BCA ASSESSMENT REPORT

**SYD05-06-07 DATA CENTRE
MAMRE ROAD, KEMPS CREEK**

Date: 22 March 2021

Figure 2 – Rise in Storeys Assessment (Greenbox Drawing No. A-I-0092 Revision 2 dated 15.03.2021)

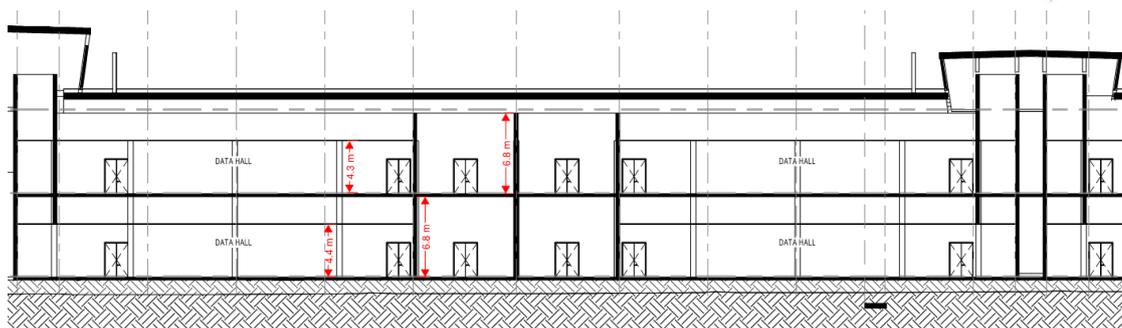
Comments: The buildings have a rise in stories of three (3), based upon the following assessment of the design:

- The lift lobby enclosures on the Roof Level of each building over the Data Halls constitute a stand-alone storey.
- The **average** internal height of Level 1 & 2 in each building does not exceed 6m (due the installation of a ceiling within each Data Hall) and as such each storey is counted as one storey per C1.2(c). Given that the Data Halls do occupy the entire floor area of each storey in the COLO, the Architect is required to provide confirmation of the % of floor area dedicated to corridors and ancillary rooms where no ceiling is proposed to be installed. See mark-up over-page in Figure 1

Note: The Trial Design of the Fire Engineering Report for the buildings will need to include a detailed specification for Cold Shell Data Halls that are not fitted out / completed and do not have ceiling installed at partial OC Application stages, to limit use and support the assessment of Clause C1.2(c) per dot point 2 above.

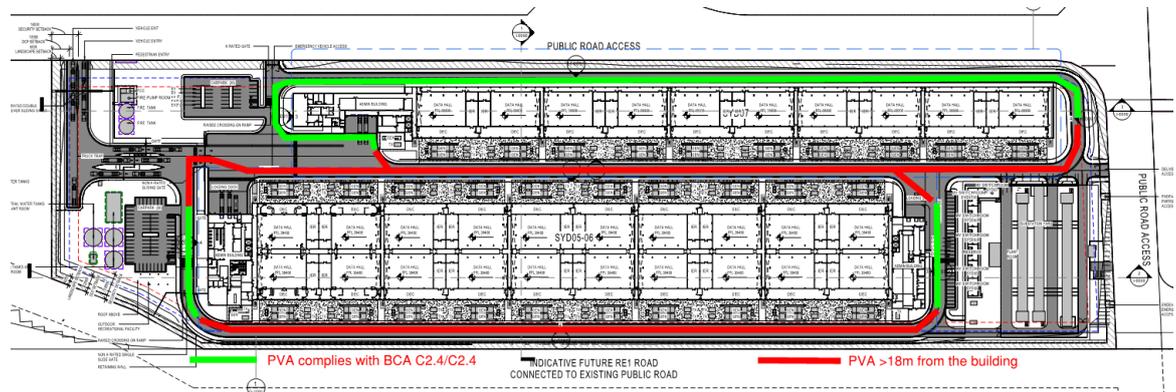
Comments: The proposed Data Centre building does not comply with the provisions of C2.4 in the areas identified in the mark-up below - we note a performance solution has been proposed by Arup in the FEBQ dated 01.05.2020 to address this issue:

- + The furthest part of the vehicular access path is greater than 18m from the external walls of each of the Data Centre buildings as detailed in the mark-up below:

Note 1: All gates are required to achieve no less than 6m unobstructed width or the reduced width.

Note 2: The driveways providing vehicular perimeter access must be designed with adequate loading capacities to withstand a fire truck and the gradients of the ramps should take into consideration the FRNSW Policy 4 Vehicular Access Guideline.

Note 3: The Trial Design for the Fire Engineered Performance Solution must take into consideration and detail the proposed security access to the site and how this may impact on FRNSW vehicular access.
